SERVICE INFORMATION NO. SI 20-056

Rotax Alert Service Bulletin ASB-912-061R1
ATA-Code: 73-00

Replacement of the pressure side fuel hose at fuel pump part no. 893114 for ROTAX® Engine Type 912 (Series)

Fig. 1
Fuel pump

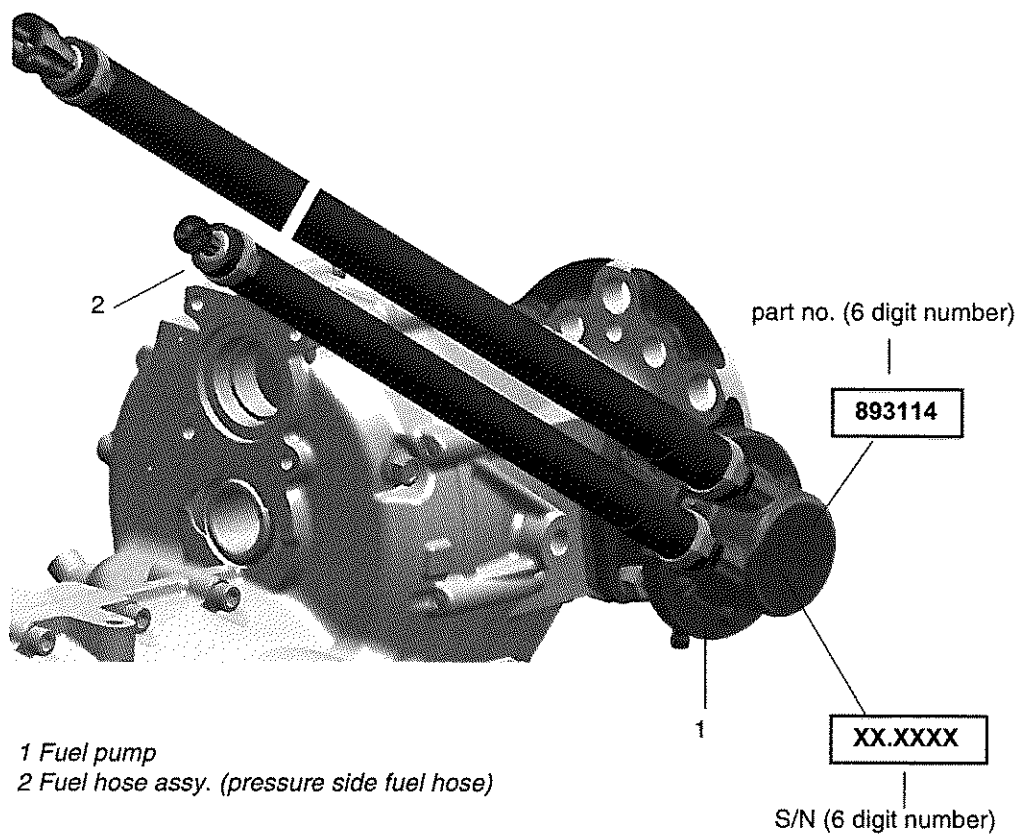
Rotax has issued Alert Service Bulletin ASB-912-061R1 prescribing replacement of the pressure side fuel hose at fuel pumps with a certain part number. ASB-912-061R1 revises ASB-912-061 dated 26-May-2012.

if they are equipped with the genuine ROTAX® fuel pump part no. 893114.
See Fig. 1

Fig. 2
Carburetor, Fuel pump

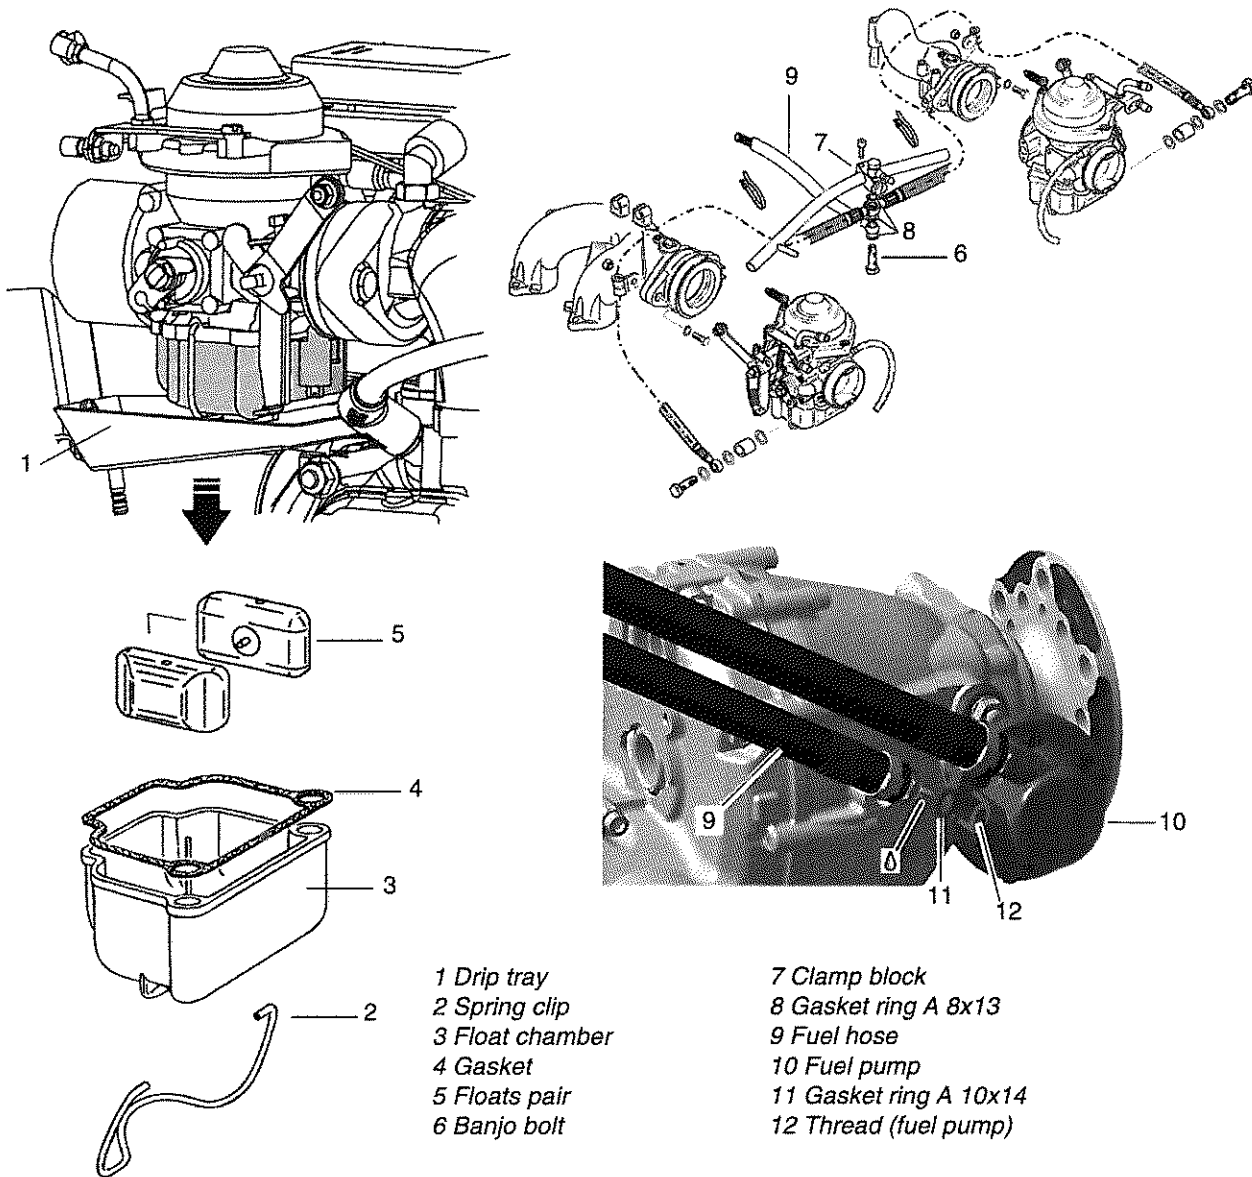
Due to variations in the manufacturing of the fuel hose, rubber particles may become detached.
These particles can interfere or suppress the fuel mixture in the carburetor. This disturbance in the
fuel mixture may lead to rough engine operation, engine misfire and can cause an engine shut
down.

Step	Procedure
1	Remove banjo bolt (6) from clamp block (7) together with 3 gasket rings (8).
2	Remove the fuel hose (9).
3	Remove the fuel hose (9) from the fuel pump (10) together with gasket ring (11).

Step	Procedure
1	Inspection of the thread (12) from the fuel pump and remove possible sealing materials.
2	Clean and degrease thread (12) of the fuel pump.

Step	Procedure
1	Install the new fuel hose (9) and new gasket ring A 10x14 (11) with LOCTITE 243 on the fuel pump. Tightening torque 10 Nm (90 in.lb).
2	Install fuel hose (9) and the banjo bolt (6) with new gasket ring (8) on the clamp block (7). Tightening torque of banjo bolt (6) 10 Nm (90 in.lb). Check that the fuel hose is not under strain or tension.

Bild 1
Kraftstoffpumpe

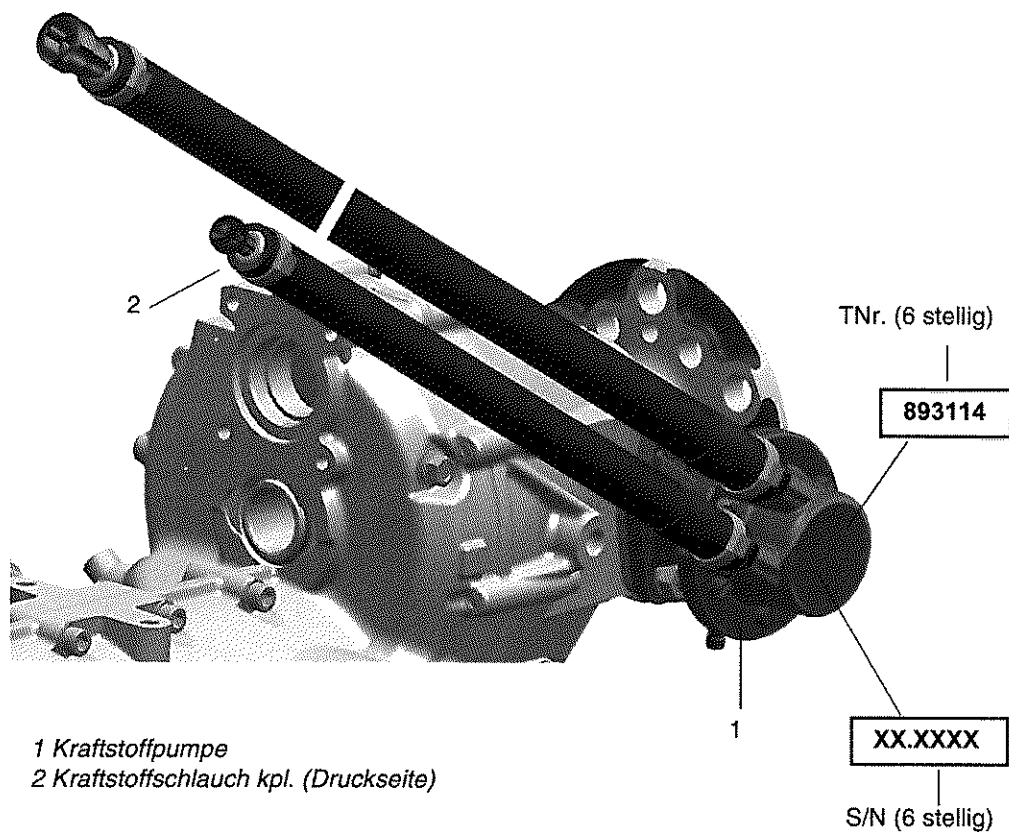
sofern diese mit der ORIGINAL ROTAX® Kraftstoffpumpe TNr. 893114 ausgestattet sind.
Siehe dazu Bild 1.

Bild 2

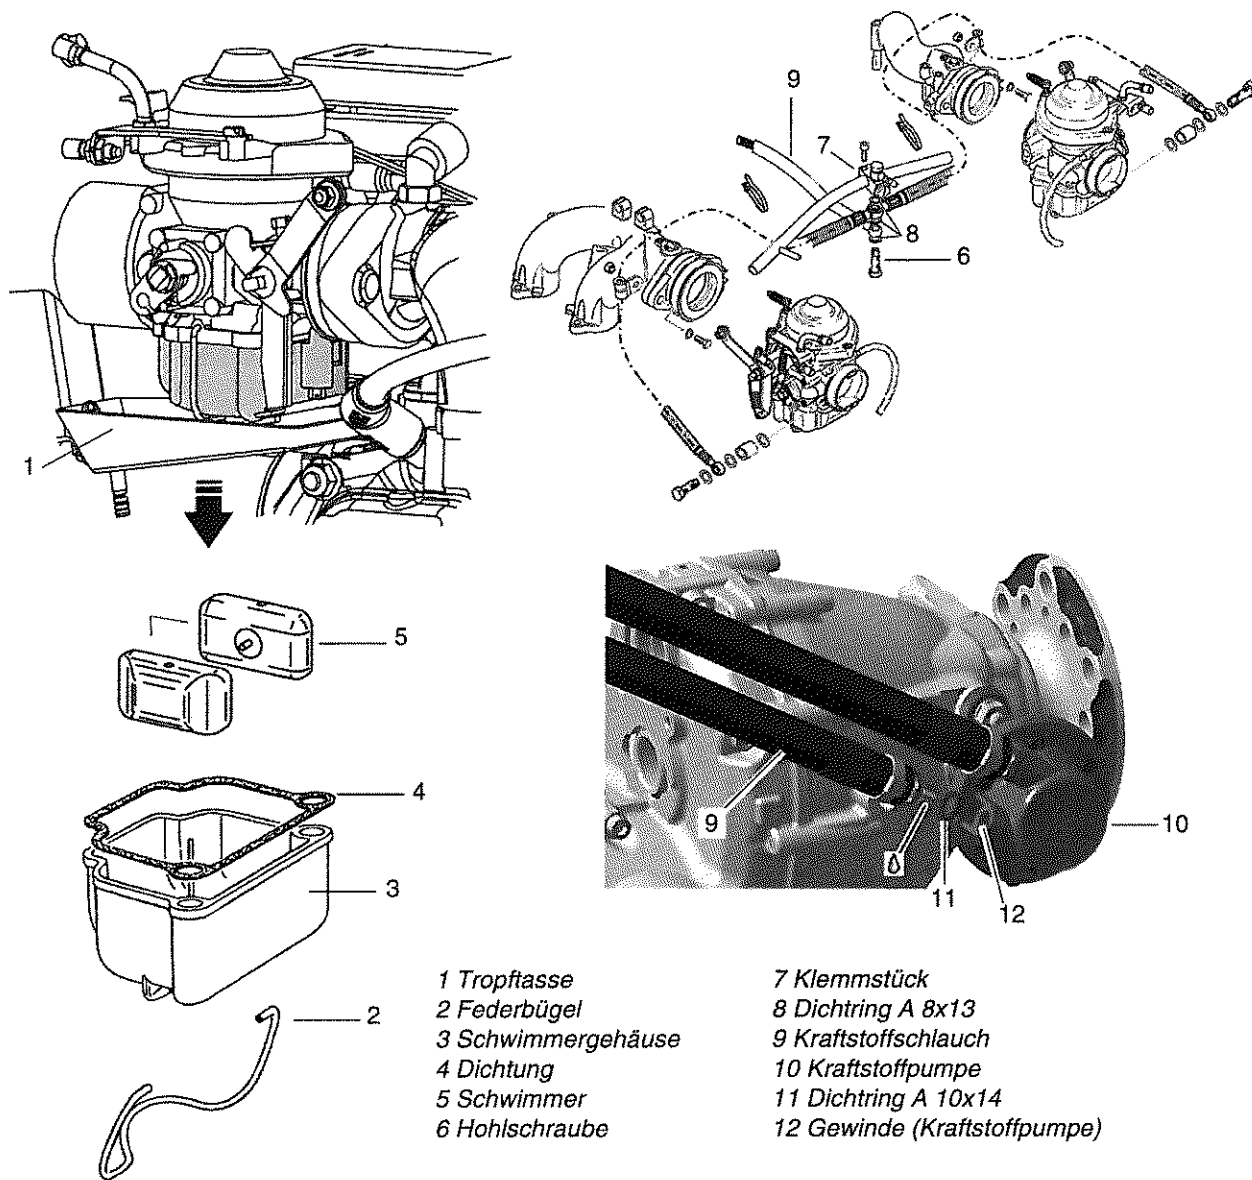
Aufgrund von Abweichungen im Herstellprozess des betroffenen Kraftstoffschlauchs, kann es zu
Ablösungen von Gummipartikeln kommen. Diese Partikel können die Gemischaufbereitung im
Vergaser behindern bzw. unterbinden. Diese Störung in der Gemischbildung führt unter Umstän-
den zu rauen Motorlauf, Motoraussetzer und eventuell zum Motorstillstand.

Schritt	Vorgehen
1	Untere Hohlschraube (6) vom Klemmstück (7) abschrauben und samt 3 Dichtungen (8) entfernen.
2	Kraftstoffschlauch (9) abnehmen.
3	Kraftstoffschlauch (9) von der Kraftstoffpumpe (10) samt Dichtring (11) abschrauben.

Schritt	Vorgehen
1	Anschlussgewinde (12) der Kraftstoffpumpe kontrollieren und gegebenenfalls Dichtungsreste entfernen.
2	Anschlussgewinde (12) der Kraftstoffpumpe entsprechend reinigen und entfetten.

Schritt	Vorgehen
1	An der Kraftstoffpumpe den neuen Kraftstoffschlauch (9) mit LOCTITE 243 sichern und mit einem neuen Dichtring A 10x14 (11) montieren. Anzugsdrehmoment 10 Nm.
2	Kraftstoffschlauch (9) spannungsfrei verlegen und mit Hohlschraube (6) samt neuen Dichtringen (8) am Klemmstück (7) montieren. Anzugsdrehmoment der Hohlschraube (6) 10 Nm.
